Guildford Town Centre Public Domain Plan Feedback

Thank you for the opportunity to comment on the Guildford Town Centre Public Domain Plan (The Plan).

Marked-up map from Open Street Map (Cycle Map layer)

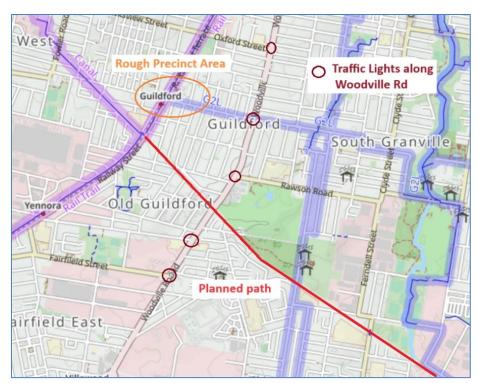
One of the challenges traversing east-west is crossing Woodville Rd. The planned canal extension does this by constructing a bridge to cross, while Guildford Rd (East) has a signalised intersection. As shown on the map to the right, signalised crossings of Woodville Rd can also be made either side of Guildford Rd (East) at Oxford St and Rawson Rd.

Thin blue lines are shared paths, wider semitransparent lines depict local/regional routes, both on and off road.

Figure 6: Guildford Town Centre Transport and Open Space

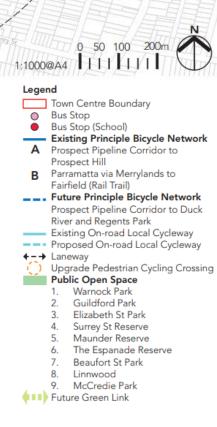
While Guildford Rd (East) may be usable for more experienced riders who don't mind mixing with some traffic, it's not presently the sort of road that would be used by less confident riders. In Figure 6 above, Mountford Ave, which runs parallel to Guildford Rd (East), is marked as a proposed on-road cycleway. This is probably a more appealing alternative for less experienced riders and appears to have a better gradient to boot. However, as there is no signalised crossing of Woodville Rd, any riders would need to come back to Guildford Rd (East) to cross. Using this as an alternative again draws riders away from the shops of the Town Centre precinct.
